# CABINET MEMBER FOR ENVIRONMENT – 28 MARCH 2019 ABINGDON – DUNMORE ROAD PROPOSED TOUCAN CROSSING

#### **Report by Director for Infrastructure Delivery**

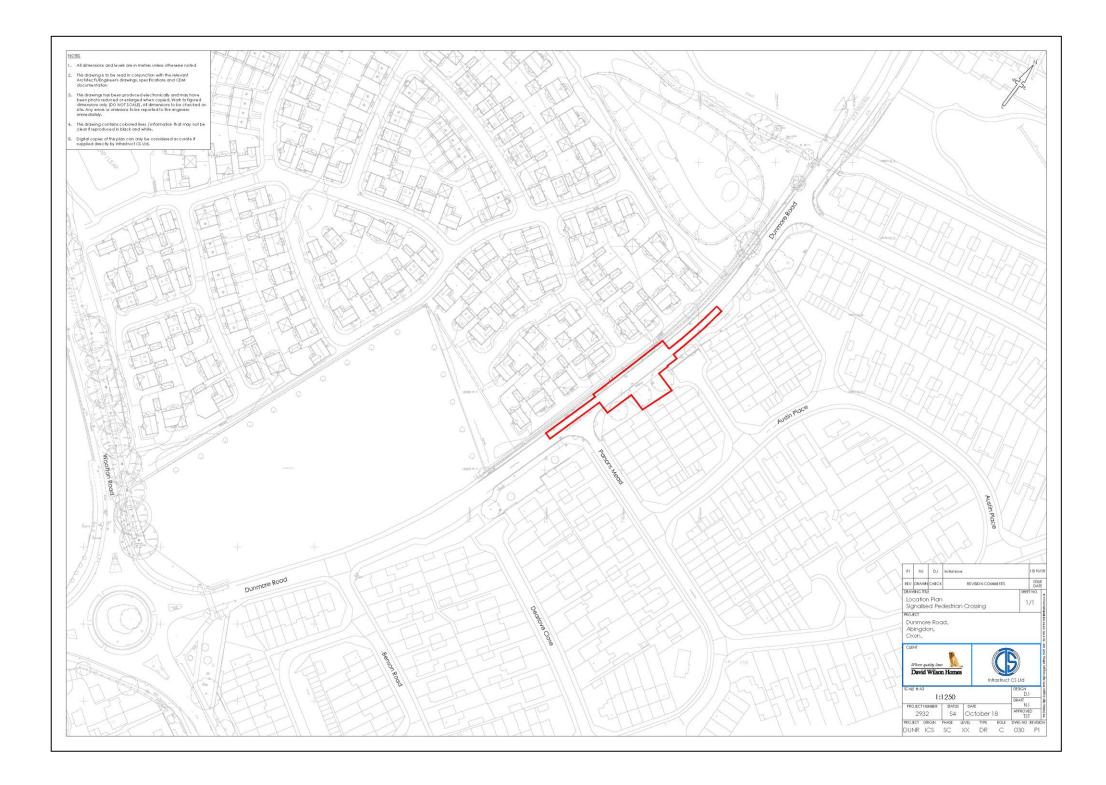
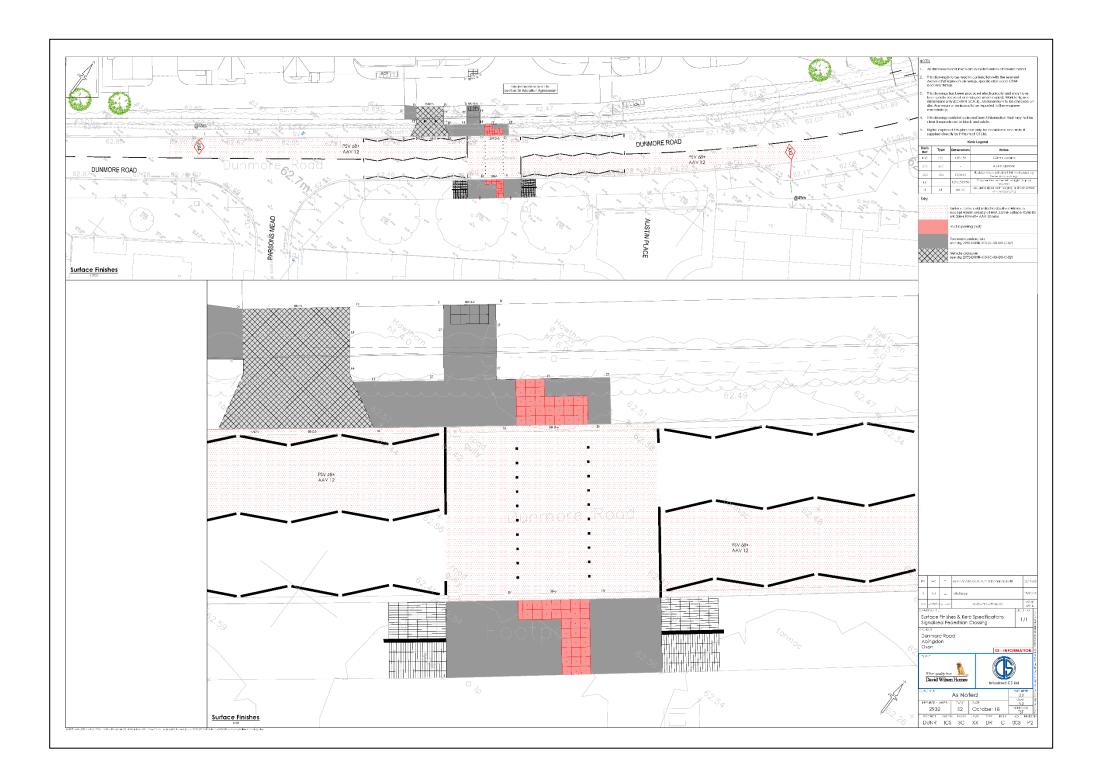
(3) Local Resident, (Abingdon)	<b>Object</b> – there are already 2 crossings either side of the proposed! Will one of these be removed? Or the plan is to have 3 crossings in a short space!?

(4) Local Resident, (Abingdon)	Object —I do not object in totality to a crossing nor to the rough location as it warrants good choice for links through to Northcourt road, primary schools, secondary schools and the college. However, there is the existing crossing located right next to the Wootton Road roundabout and then a further one next to Tilsley park. This seems an excessive number in a relatively short distance. It would seem sensible to locate the new crossing marginally closer to the Wootton Road roundabout and to remove the existing one positioned right next to it, which can lead to congestion. Additionally, if I am reading the plans correctly there is to be a vehicular crossing almost directly opposite the entrance to Parson's Mead which could lead to more congestion in peak times. Has it perhaps been considered to implement a mini roundabout linking Parsons Mead, Dunmore Road and this new Unclassified road? Or make it a closer/4-way intersection so that on the rare occasion traffic at peak times does stop 2 cars can benefit? Furthermore, I am aware that the full junction at Lodge Hill has been discussed lately but is this also part of this development or will this sneak in prior to that completing, causing yet more congestion at peak times. Has there been consideration in creating (Farm Road?) better access between Dunmore Road side by Tilsley Park and Oxford Road/ Northcourt Road whilst trying to ease congestion on Dunmore Road?

(5) Local Resident, (Abingdon)	Object – As a resident of Parsons mead, I have spoken to other residents here and we are all of the same opinion that-  1. The traffic is already very bad in rush hour and that having more houses and in turn more cars on Dunmore road will worsen this.

2. Parsons Mead is still being used as a rat run with cars speeding down and cutting through to Beverly close.  I am only in favour of this crossing if you can tell us if-  1. The Dunmore roundabout WILL be reinstated as a true 2 lane roundabout to handle the increase in traffic?  2. The current pedestrian crossing very close to the Dunmore roundabout will NOT also be there?  3. There will be NO access other than for emergency vehicles to the new housing estate on Dunmore rd opposite to Parsons mead as it is already very hard and dangerous for us to get out of Parsons mead onto Dunmore rd?  4. Dunmore road will become a 30mph zone OR a speed camera will be put in as many cars speed down this rd?  Why don't you move the speed camera on Wootton Rd and put it on Dunmore rd where it will actually be of use?

- 10. While the above objections are noted it is not considered that the proposals will increase traffic congestion. Also the spacing of crossings on Dunmore Road, should the proposal be approved, will not be untypical of other comparable roads and, by facilitating the safe crossing of pedestrians and cyclists, should help encourage walking and cycling trips thereby in turn helping reduce demand for car travel and the associated delays and congestion arising from additional traffic.

- 11. In respect of the wider concerns raised over traffic pressures in the area, including the future impact of approved development, and the suggestions for measures to address these, while noted, they are not considered to be material to the case for approving the crossing as proposed.
